Accessibility Design Review – DA Review

Project Title: Proposed SEPP Seniors Living – Self Contained Dwellings
27 Bellevue Avenue, Avalon

Date: 24 June 2020

Report Version: 9135_ADR_v1.0

Cl. D3.11: Ramps

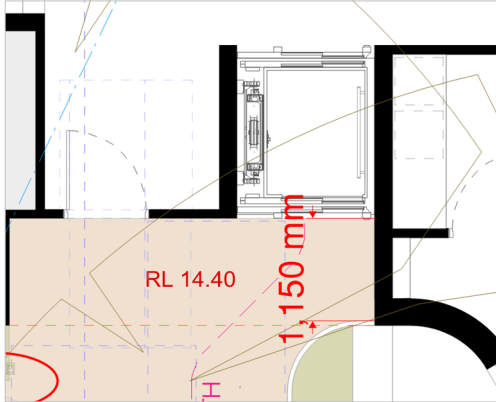
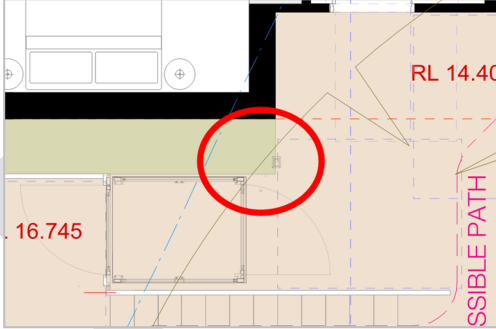
<p>Resolution:</p> <p>Provide a minimum 1500mm x 1500mm lower landing in accordance with AS1428.1-2009.</p> <p>Compliance Departure:</p> <p>Landings are not provided at the change of directions along the 1:20 ramp between Apartments 2 and 3, refer below.</p>  <p>Resolution:</p> <p>Provide landings at each change in direction along the 1:20 ramp or re-design it as a curved ramp with a consistent curve in accordance with AS1428.1-2009. Curved ramps must be minimum 1500mm wide.</p>	
<ul style="list-style-type: none"> for a stairway, except a fire-isolated stairway, clause 11 of AS 1428.1; and 	<p>All non-fire-isolated stairways are required to comply with AS1428.1-2009.</p> <p>Compliance Departure:</p> <p>The stairway between apartment 3 & 2 has not been set back sufficiently to allow</p>	CD

<p>for a horizontal handrail extension that does not affect the platform lift.</p>  <p>Resolution:</p> <p>Amend the area to allow for the required stairway handrail extensions without affecting the circulation space of other elements.</p> <p>Compliance Departure:</p> <p>The stairway between apartment 3 & 2 has not been indicated with an outer handrail extension at the lower landing that is perpendicular to the stair.</p>  <p>Resolution:</p> <p>Ensure compliant handrails and extensions are provided to all common area stairways in accordance with AS1428.1-2009.</p> <p>Compliance is readily achievable with minor design development and/or specification at the Detailed Design Stage.</p>	
<ul style="list-style-type: none"> for a fire-isolated stairway, clause 11.1(f) and (g) of AS 1428.1; and 	<p>N/A – no fire-isolated stairways are proposed</p>	N/A

Apartment 2

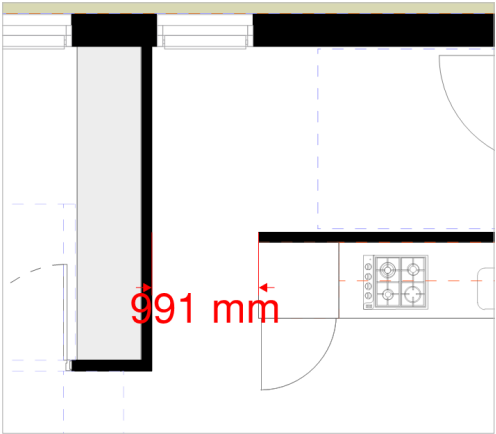
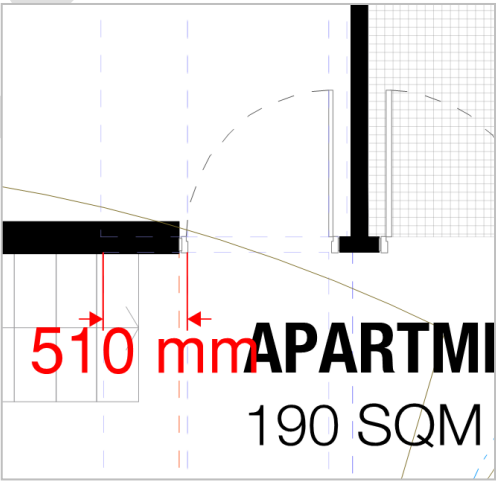
Compliance Departure:

The following doorways have reduced or no latch-side clearance.

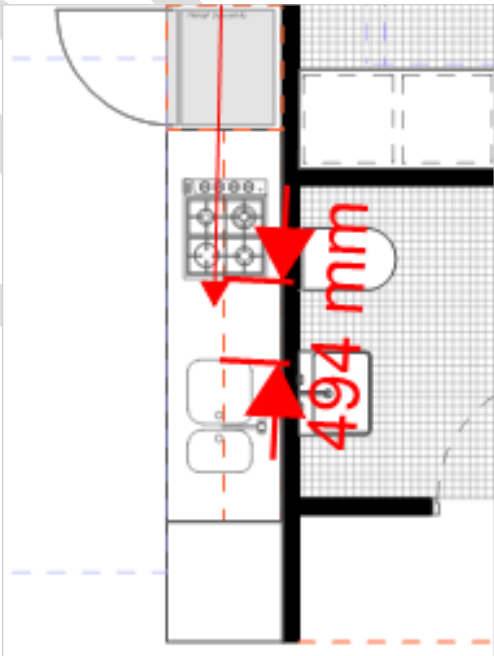
Compliance Departure –

A 1m clear corridor width is not provided at the end of the kitchen bench in Apartment 2.

<p>Resolution – Provide the prescribed 1m clear corridor width throughout the units.</p> <p>Design Detail: Please ensure compliant access is provided to balcony areas etc.</p> <p>Design Detail: Please confirm if the head height under the stairway is 2m or better for the entire doorway circulation space (apartment 3).</p>  <p>APARTMENT 3 190 SQM</p>	
<p>8 Bedroom</p> <p>At least one bedroom within each dwelling must have:</p> <p>(a) an area sufficient to accommodate a wardrobe and a bed sized as follows:</p> <p>(i) in the case of a dwelling in a hostel—a single-size bed,</p>	<p>Compliance is readily achievable.</p> <p>Location of GPOs etc to be determined at detailed design stage.</p>	<p>CoC</p>
